# UNITED STATES PATENT AND TRADEMARK OFFICE

APPLICATION NO.	FILING DATE	FIRST NAMED INVENTOR	ATTORNEY DOCKET NO.	CONFIRMATION NO.
09/918,886	07/30/2001	Ting K. Yee	20852-05682	3294

**Office Action Summary**

## DETAILED ACTION

FIG. 1

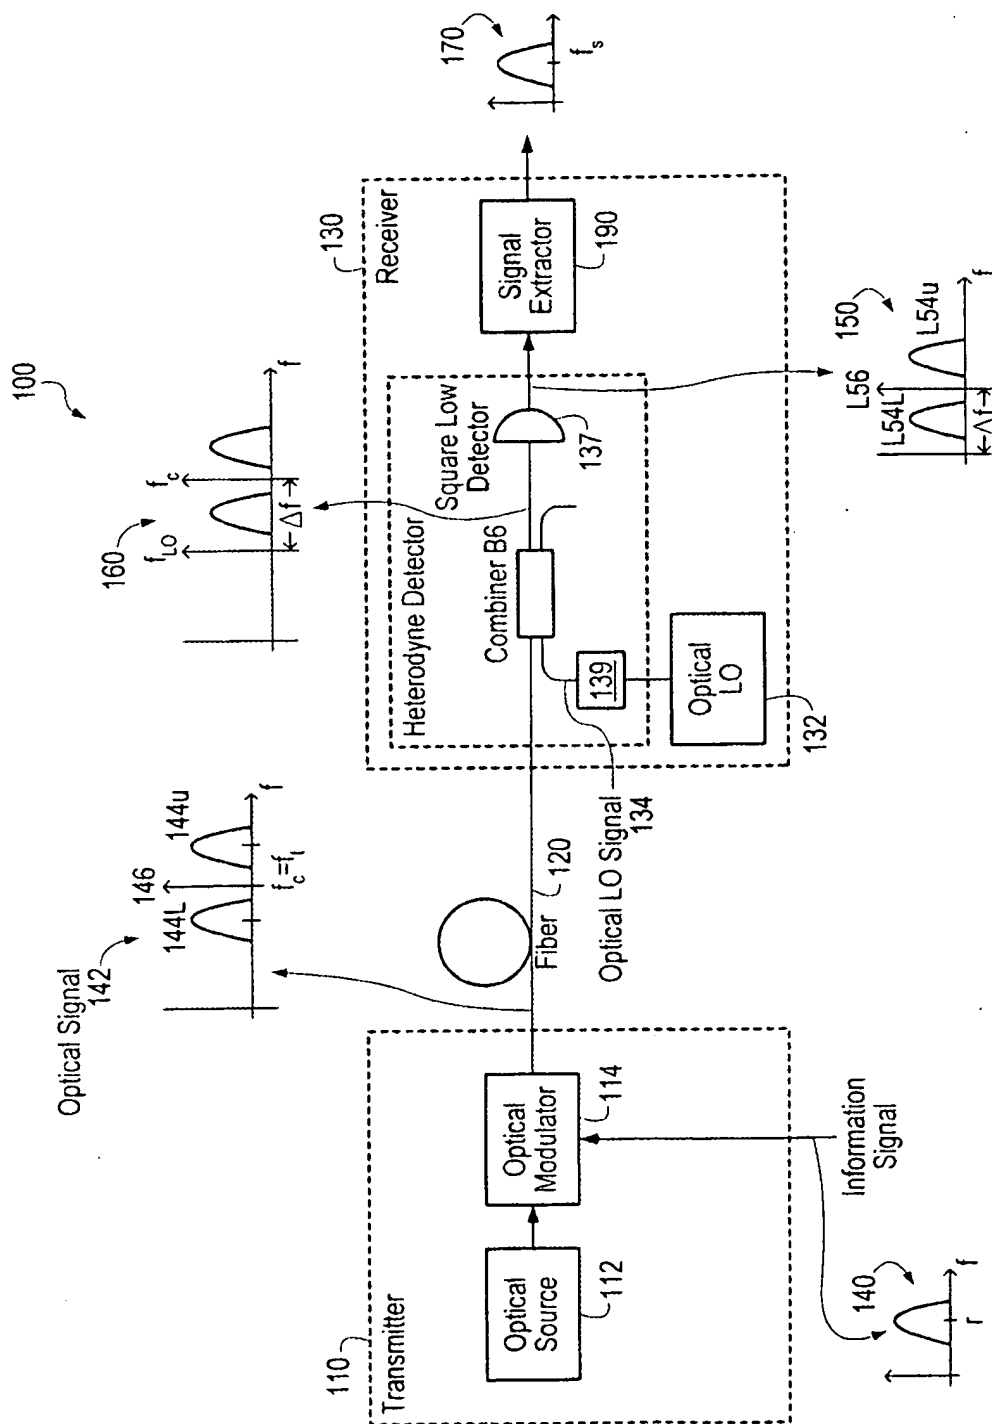
In Fig. 1, replace the frequency label "r" with "f<sub>s</sub>" under the spectrum 140. See paragraph [0056] for support.

In Fig. 1, label the heterodyne detector with "180" as in the old Fig. 1 filed on 30 July 2001. See paragraph [0055] for support.

In Fig. 1, replace reference characters "L54L", "L54u", and "L56" with "154L", "154u", and "156", respectively, as in old Fig. 1 filed on 30 July 2001. See paragraph [0059] for support.

In Fig. 1, delete “ $f_s$ ” under the reference character “170”. Paragraph [0059] teaches that component 170 may be offset from  $f_s$  instead of being located at  $f_s$  as shown in Fig. 1.

In Fig. 1, replace “B6” with “136” and replace “Low” with “Law”. See paragraph [0062] for support.

FIG. 2

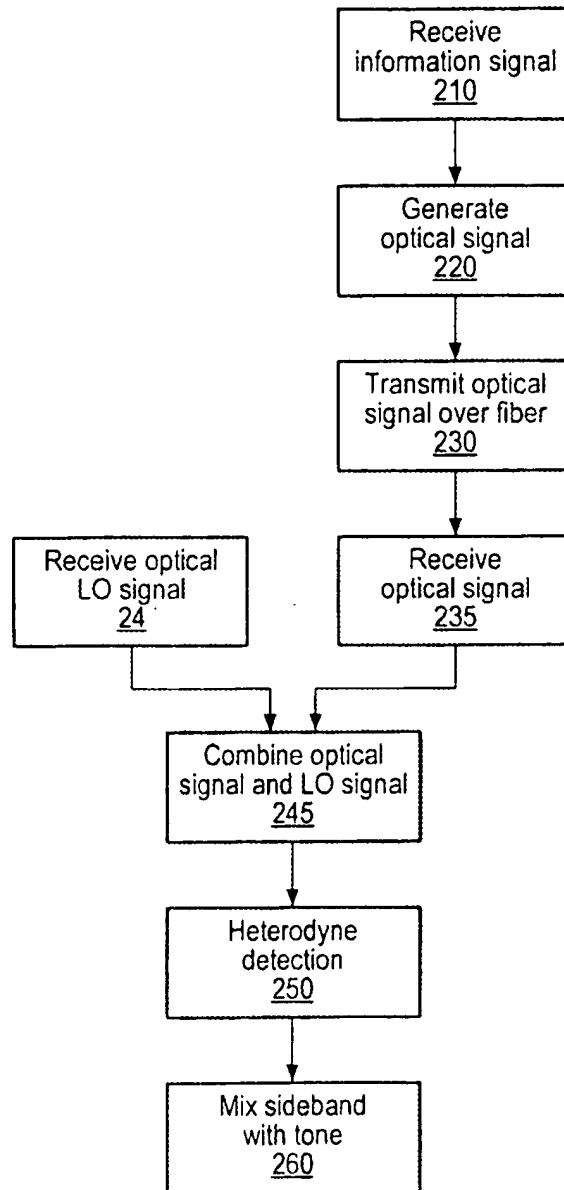
In Fig. 2, add a reference character “200” that points to the entire method. See paragraph [0028] for support.

In Fig. 2, replace reference character “24” with “240” as in old Fig. 2 filed on 30 July 2001. See paragraph [0059] for support.

FIG. 4

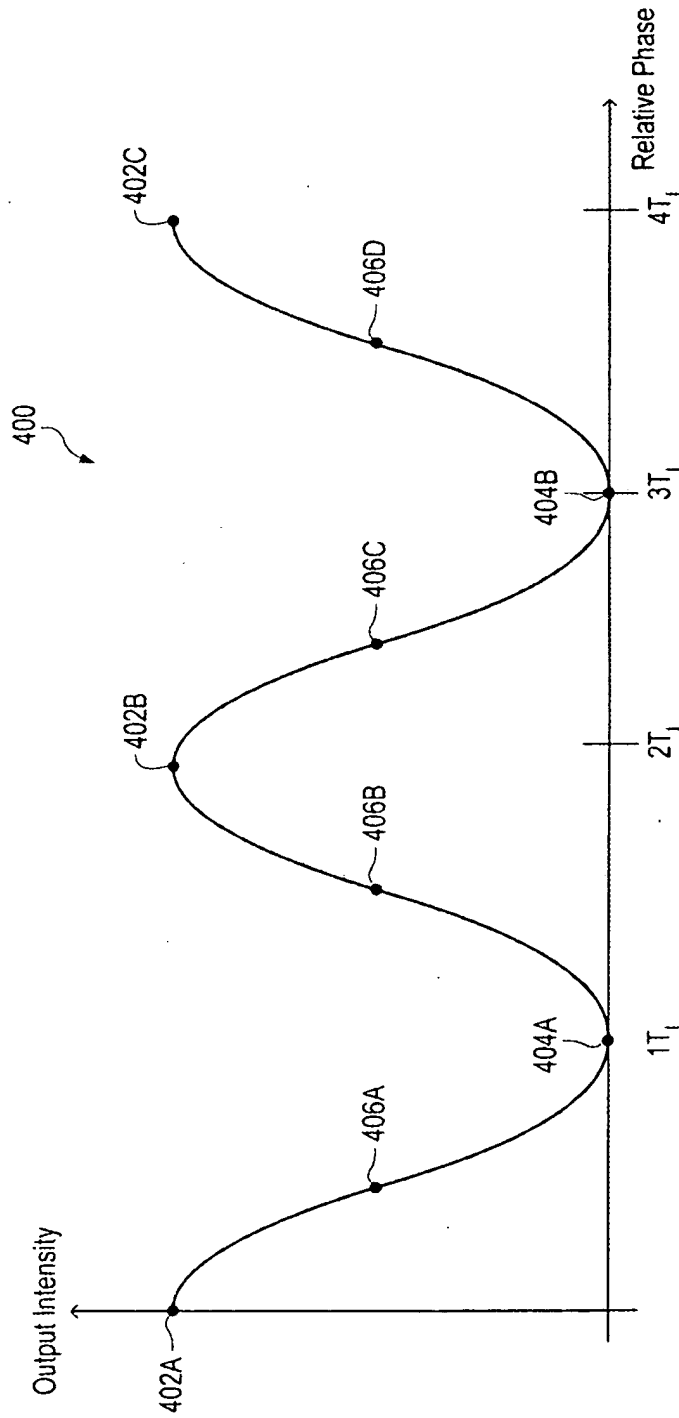
In Fig. 4, replace all instances of “ $T_1$ ” with “ $\pi$ ” as shown in old Fig. 4 filed on 30 July 2001. See paragraph [0067] for support.

FIG. 5

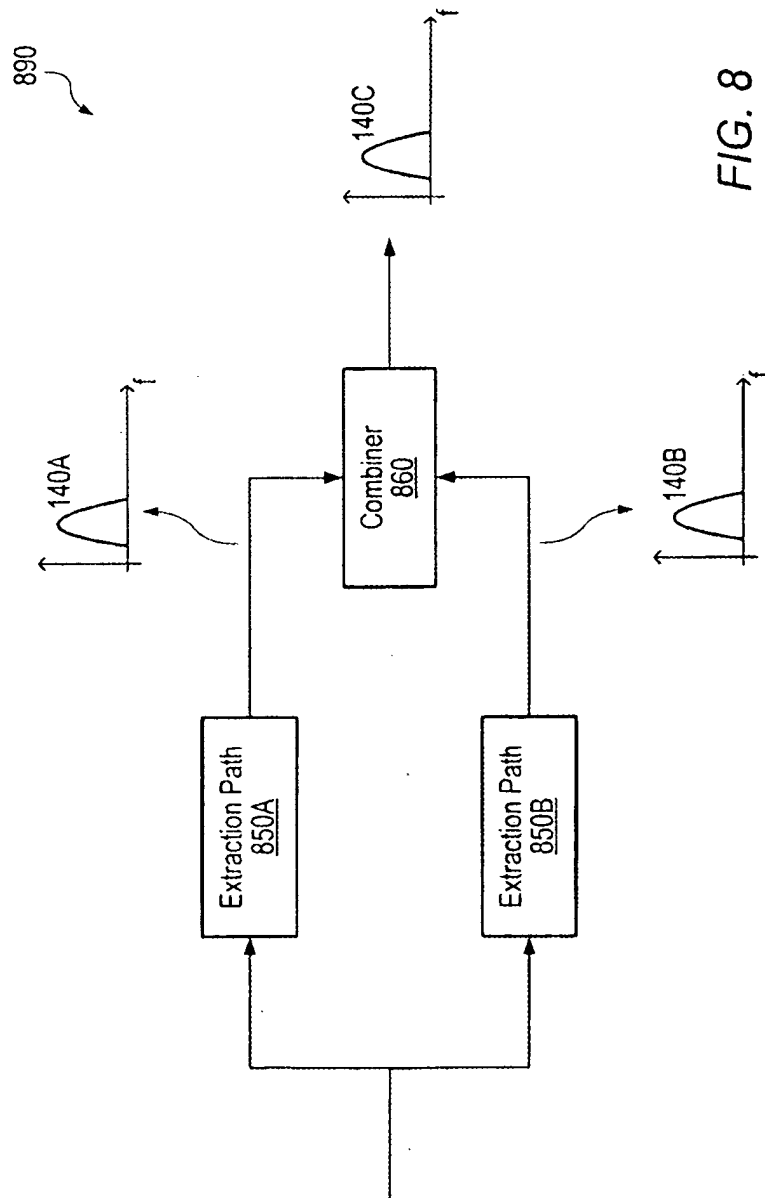
In Fig. 5, replace “Biased off Null” with “Biased at Null” as shown in old Fig. 5 filed on 30 July 2001.

FIG. 9

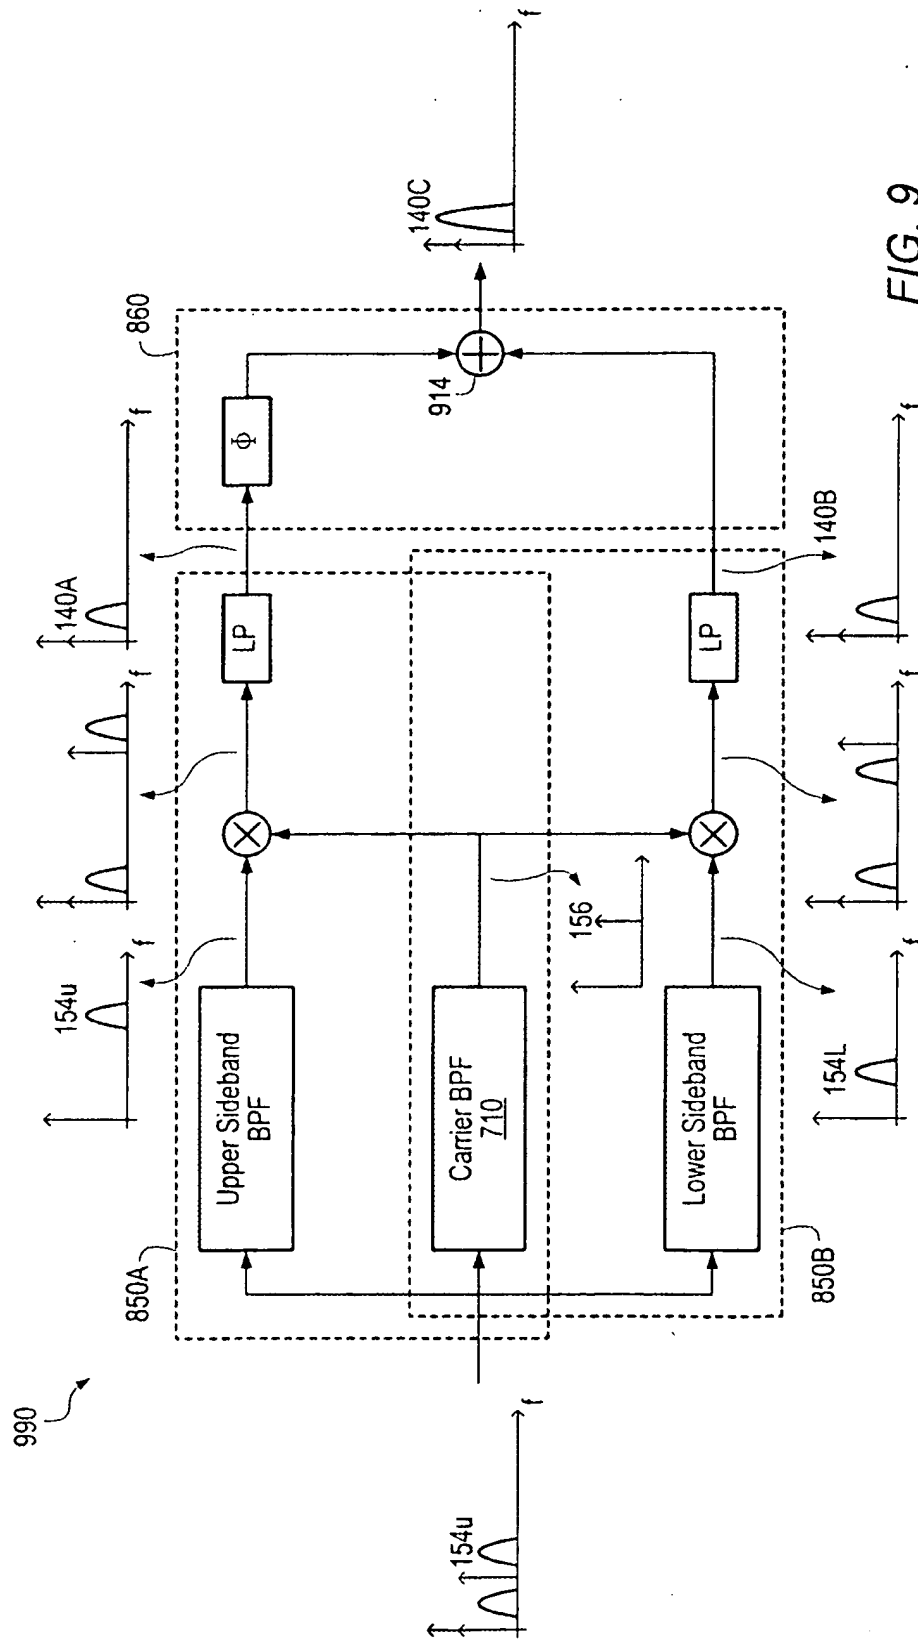
In Fig. 9, the input signal is missing labels “154L” and “156”. See how Figs. 6-7 provide these labels.

In Fig. 9, add a reference character “720” that points to the upper multiplier. Also, add a reference character “720” that points to the lower multiplier. See paragraph [0079] for support.

In Fig. 9, add a reference character “912” that points to the phase shifting element as shown in old Fig. 9 filed on 30 July 2001. See paragraph [0080] for support.

FIG. 10

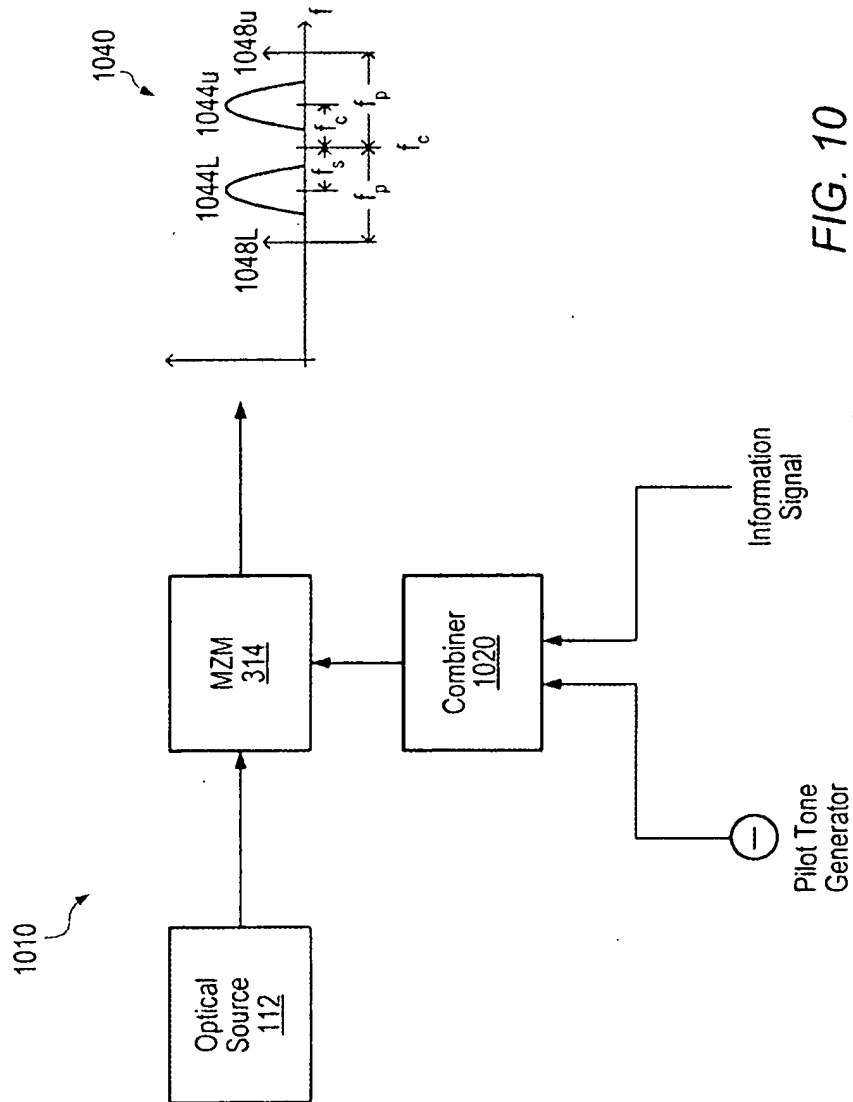
In Fig. 10, label the Pilot Tone Generator with “1030” as in old Fig. 10 filed on 30 July 2001. Also, label the Information Signal with “140” as in old Fig. 10 filed on 30 July 2001. See paragraph [0081] for support.

In Fig. 10, the spectrum drawing shows a label “ $f_c$ ” next to a label “ $f_s$ ”. Replace “ $f_c$ ” with another instance of “ $f_s$ ” so there are two instances of “ $f_s$ ” next to each other as shown in old Fig. 10 filed on 30 July 2001.

FIG. 12

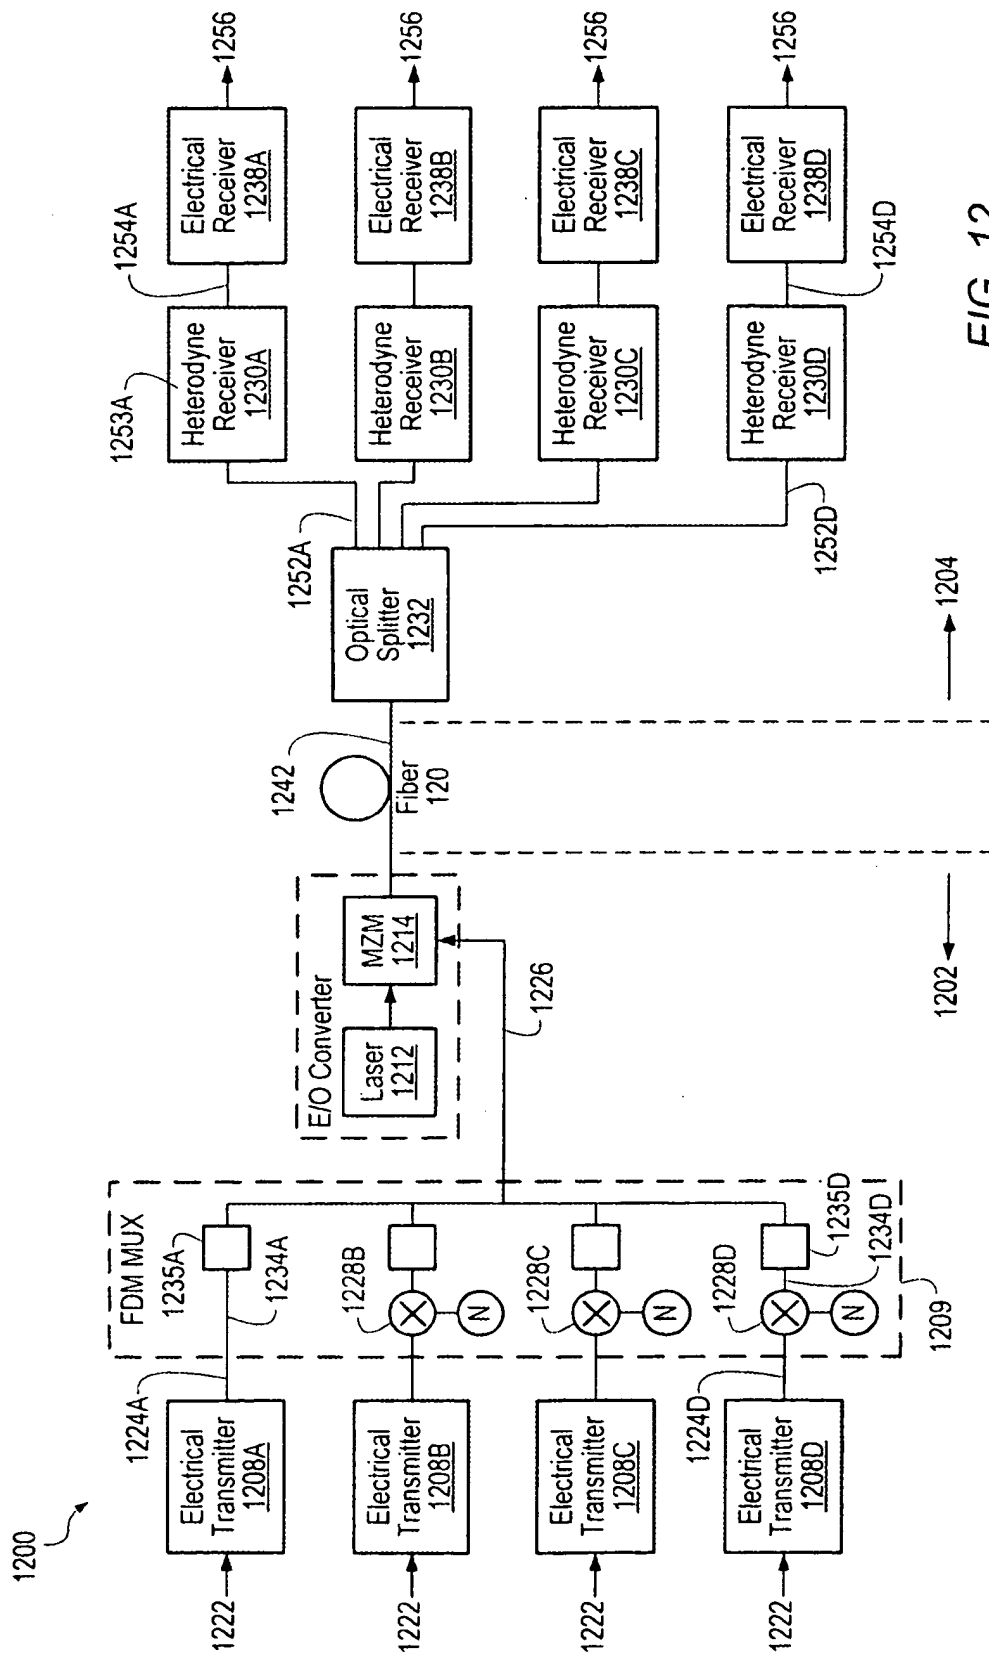
In Fig. 12, label the E/O Converter with “1210” as in old Fig. 12 filed on 30 July 2001. See paragraph [0092] for support.

FIG. 13A

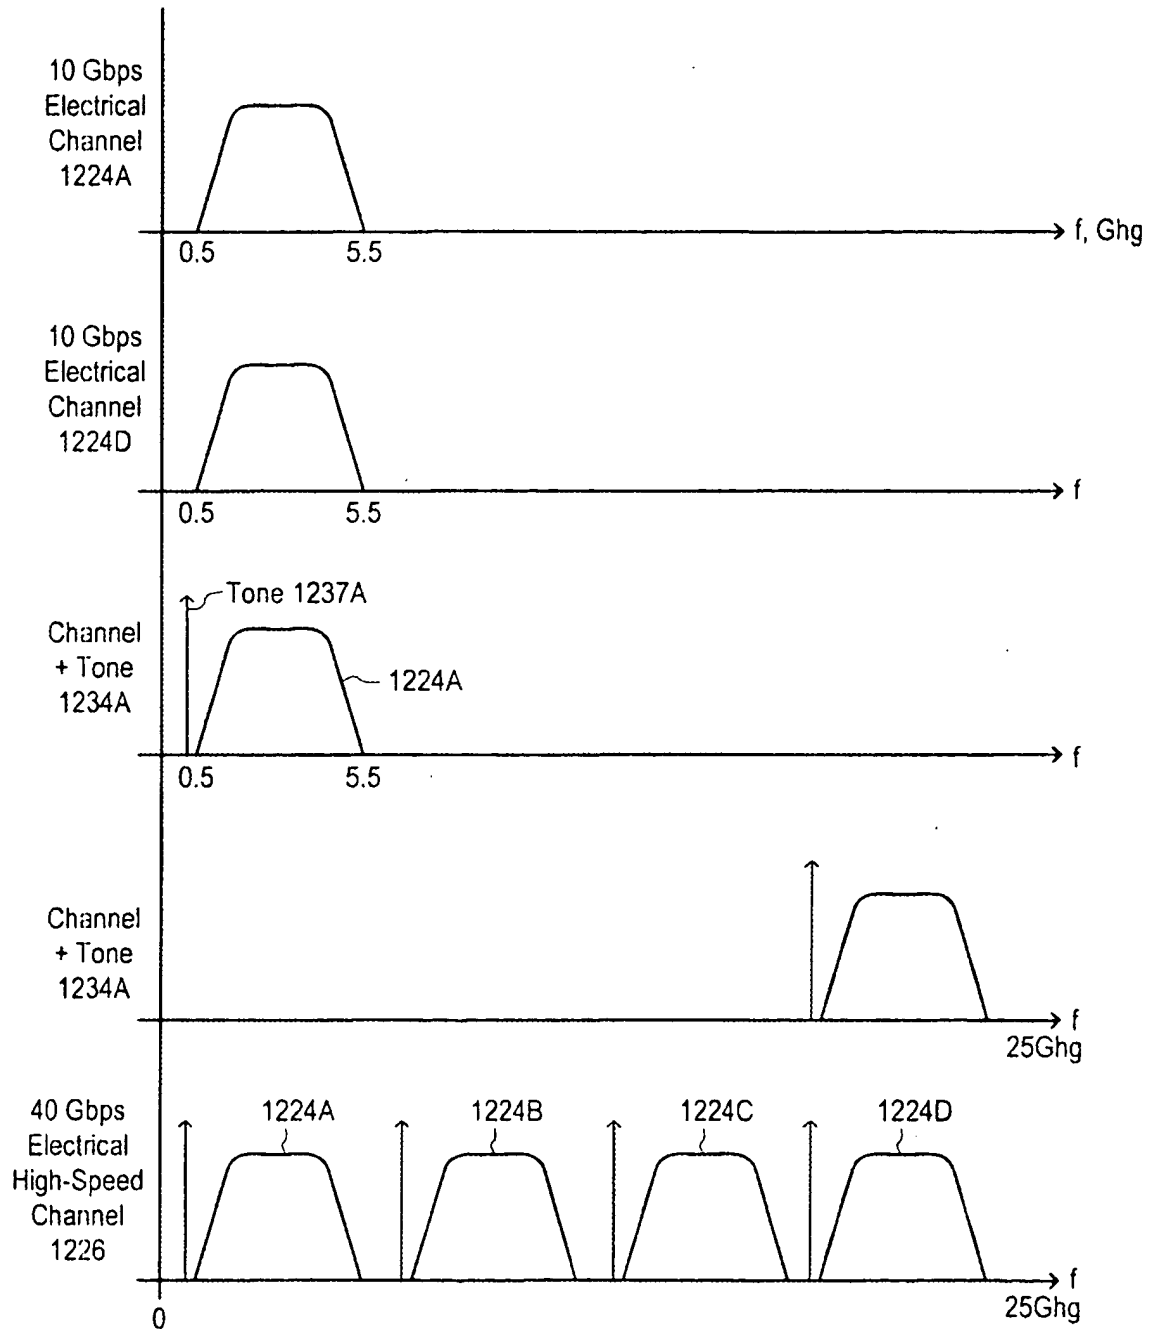
In Fig. 13A, there are two instances of “1234A”. Replace the lower instance with “1234D” as in old Fig. 13A filed on 30 July 2001. See paragraph [0093] for support.

FIG. 13E

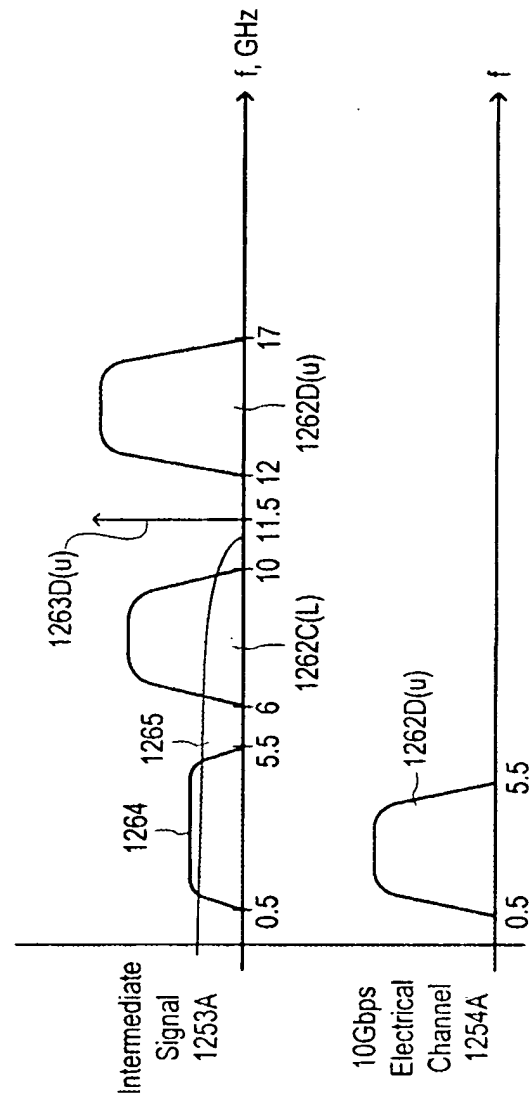
In Fig. 13E, replace “1253A” with “1253D” and replace “1254A” with “1254D” and replace “1262C(L)” with “1262C(U)” as shown in old Fig. 13E filed on 30 July 2001. See paragraph [0103] for support.

FIG. 14A

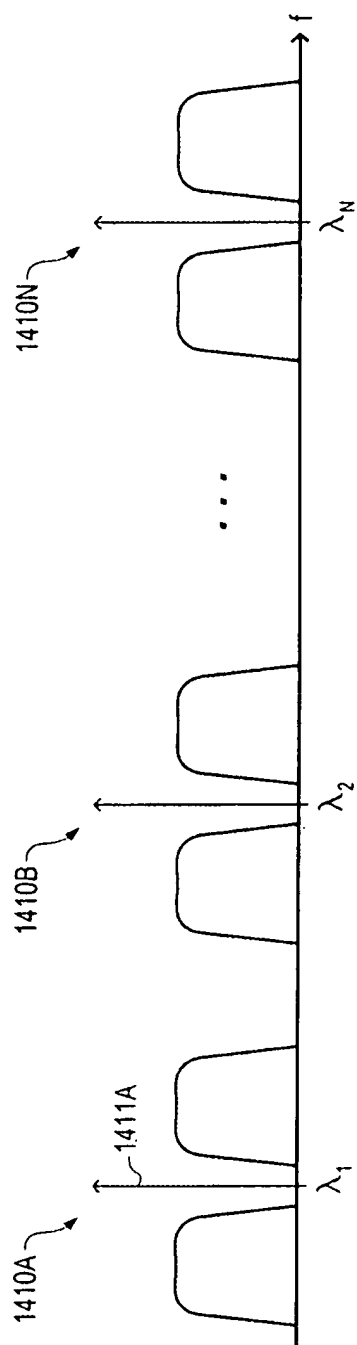
In Fig. 14A, label the lower sideband to the left of optical carrier 1411A with “1412A(L)” and label the upper sideband to the right of optical carrier 1411A with “1412(U)” as shown in old Fig. 14A filed on 30 July 2001. See paragraph [0086] for support.
